**Comment Summary – January 13, 2025 (5<sup>th</sup> Submission)**  
**Zoning By-law Amendment Application – WDD Main St. Inc.**

RE: **NPG Comments  
Main St  
RE: Application for Zoning By-law Amendment & Draft Plan of Subdivision**

**Re: Zoning By-Law Amendment 5th Submission  
11 Main Street (Morrison)  
Puslinch, ON**

**RE:** Hydrogeological Review Comments - 5th Submission  
WDD Main Street Inc. - 11 Main Street, Morriston (Puslinch), Ontario  
Proposed Residential Subdivision  
Zoning By-law Amendment / Draft Plan of Subdivision Application

Drawing  
**PRE-DEVELOPMENT DRAINAGE PLAN**

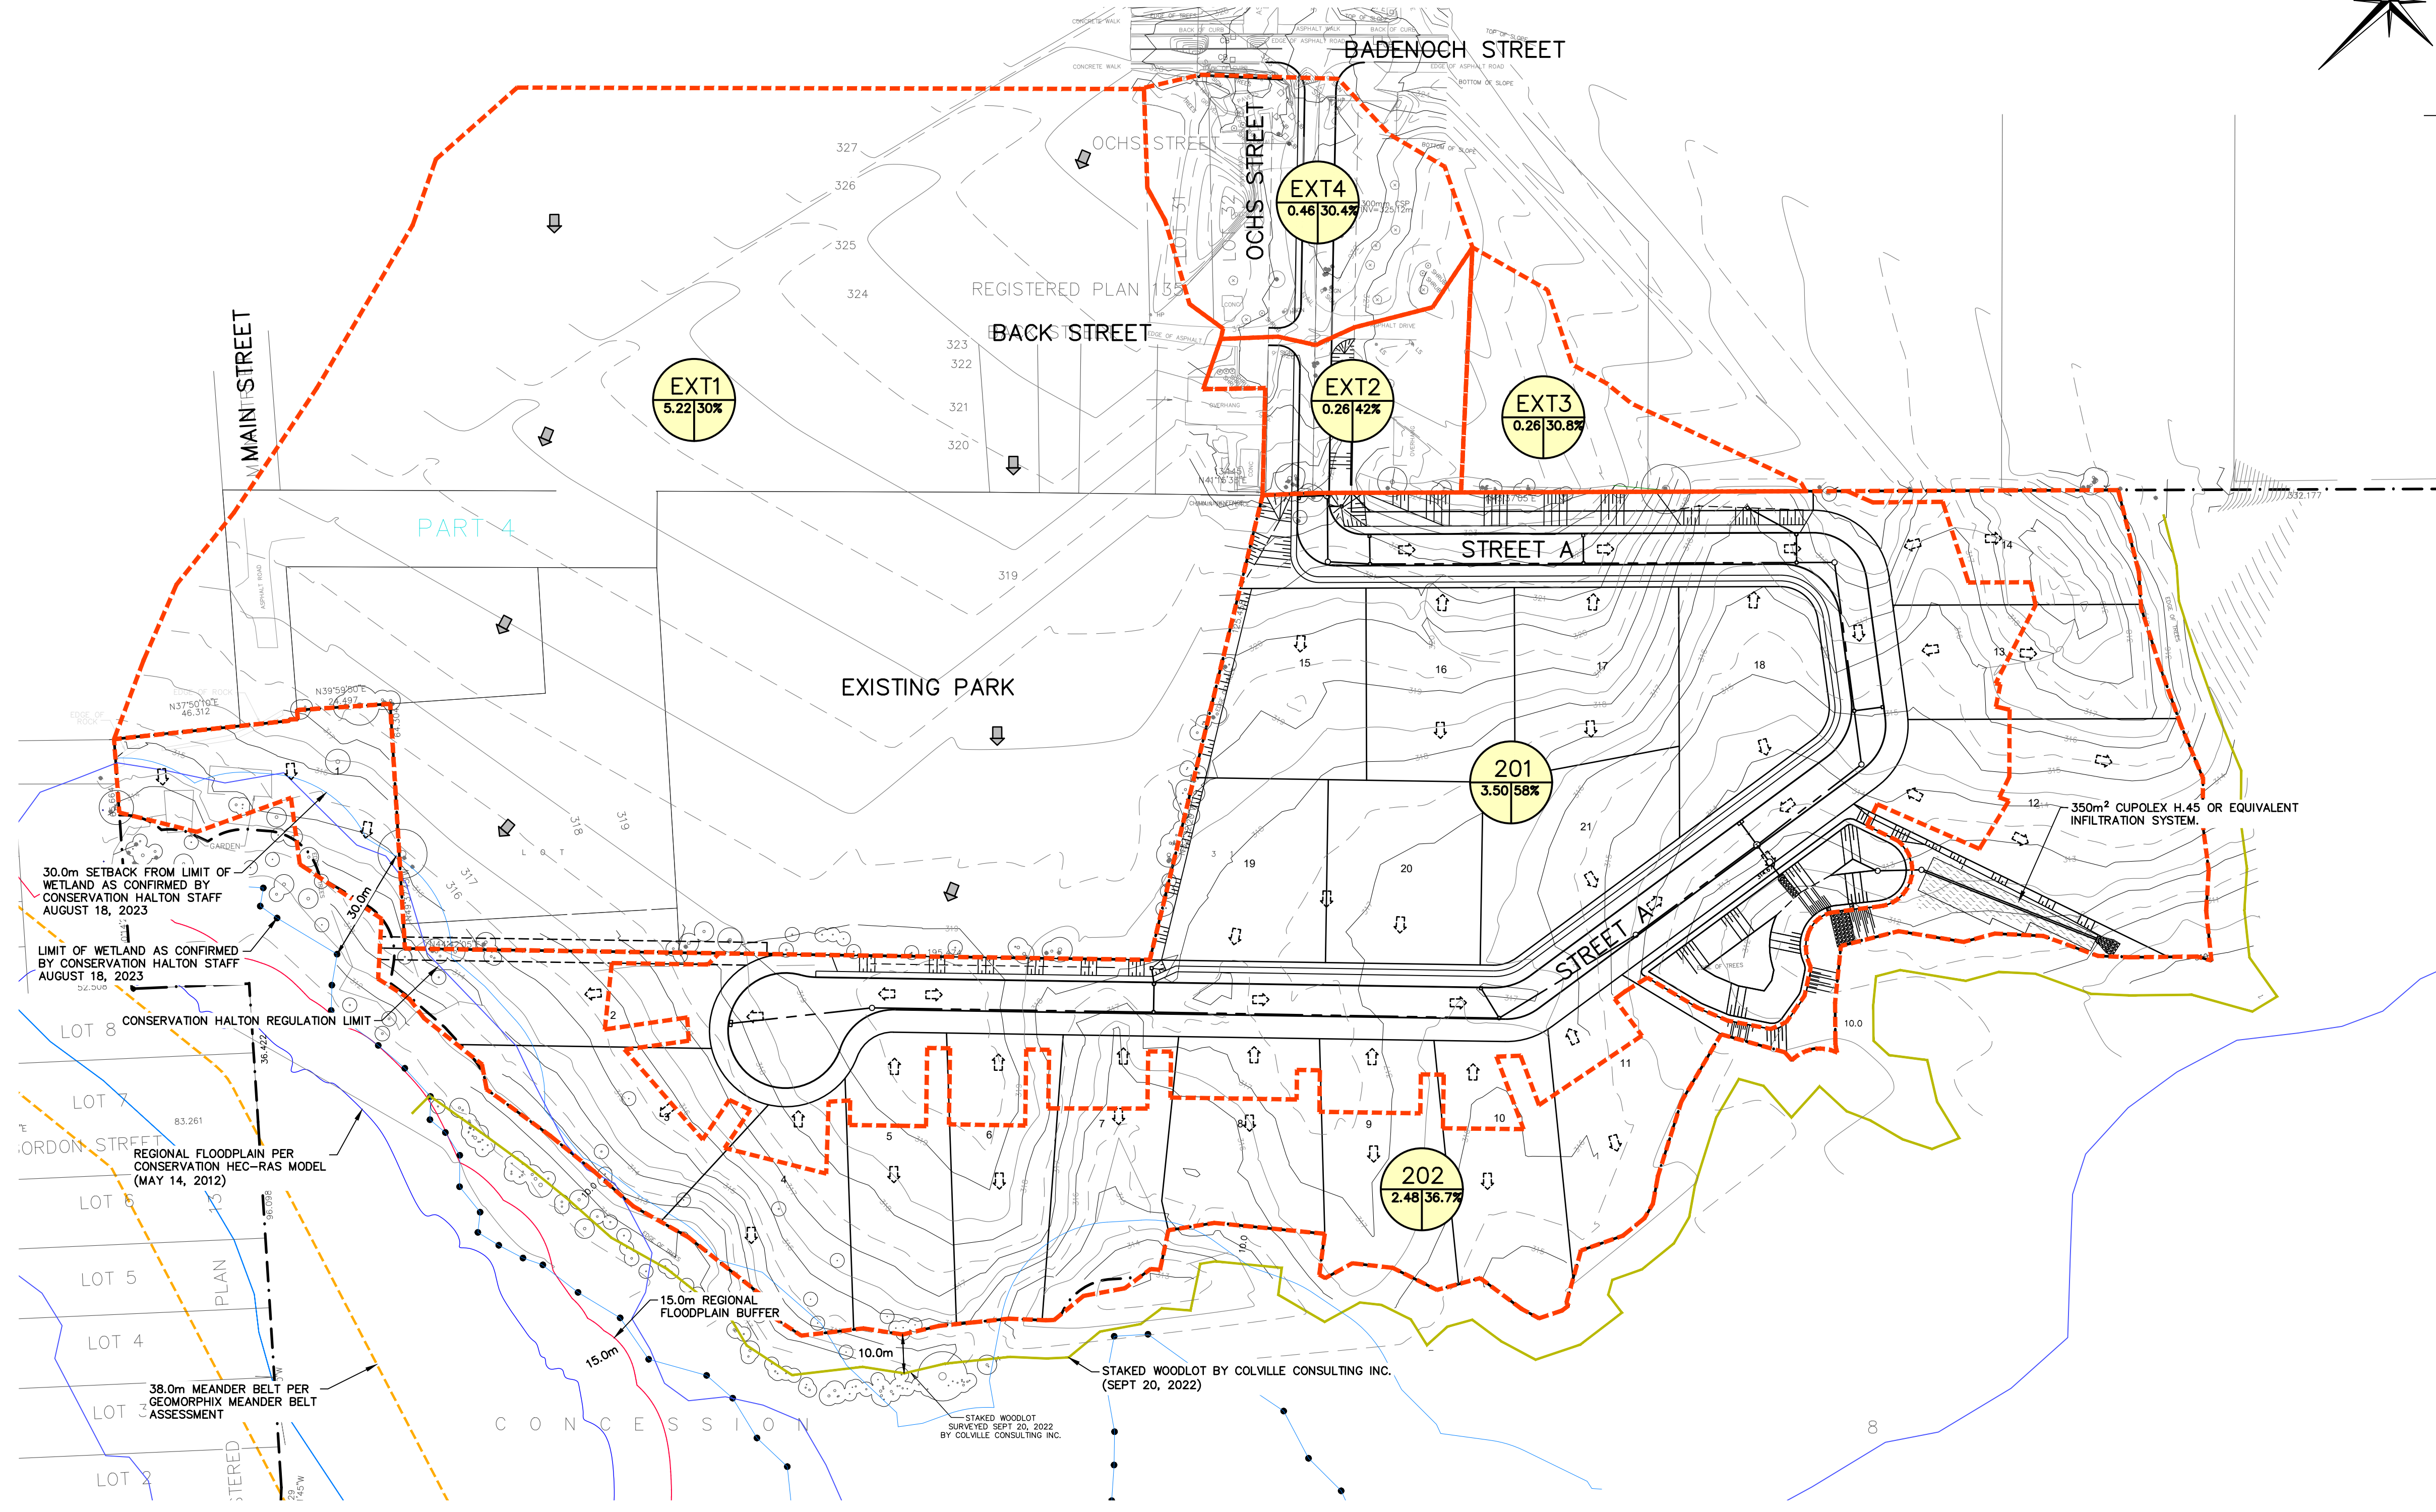
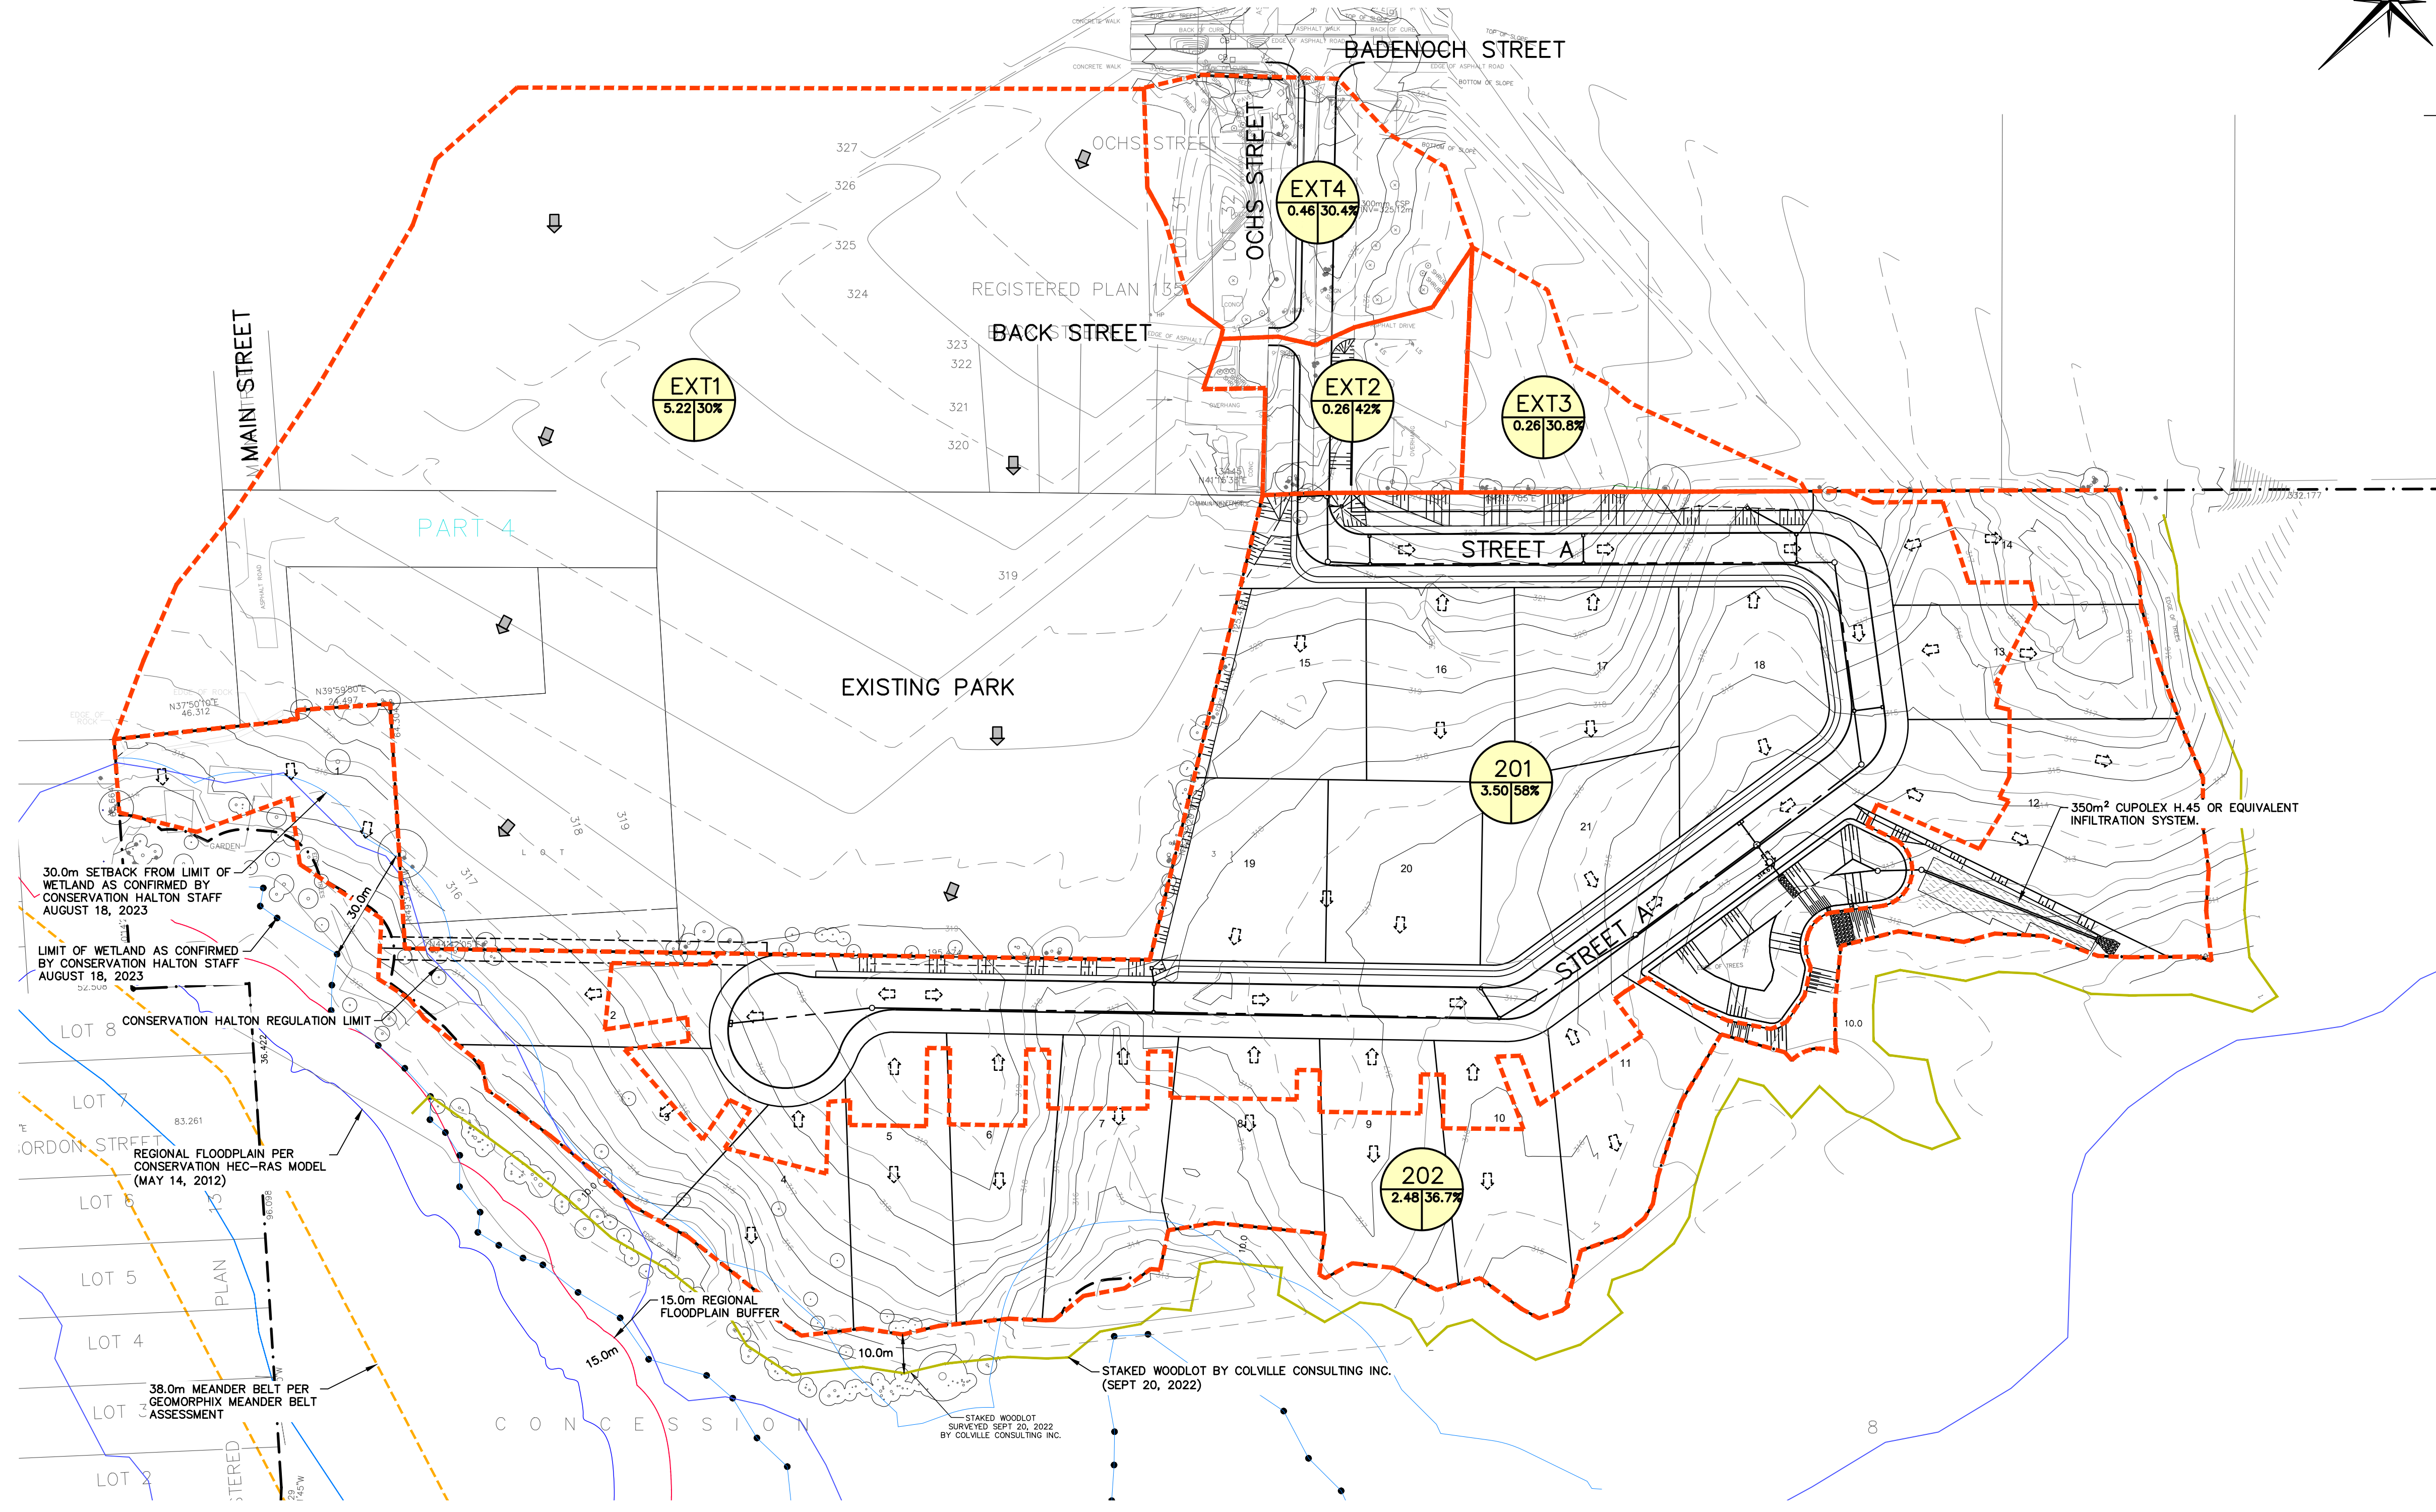
**Topography and drainage:** Section 3.1 of the Hydrogeological Assessment report indicates that “topography of the site is sloping downwards in a northwest direction. As such, it is anticipated that generated runoff (if not managed) will flow in a northwesterly direction.” This interpretation is incorrect based on the Topography Map (Figure 5).

**Topography and drainage:** Section 3.1 of the Hydrogeological Assessment report indicates that “topography of the site is sloping downwards in a northwest direction. As such, it is anticipated that generated runoff (if not managed) will flow in a northwesterly direction.” This interpretation is incorrect based on the Topography Map (Figure 5). Please revise/clarify (at the detailed design submission stage).

Please revise/clarify (at the detailed design submission stage).
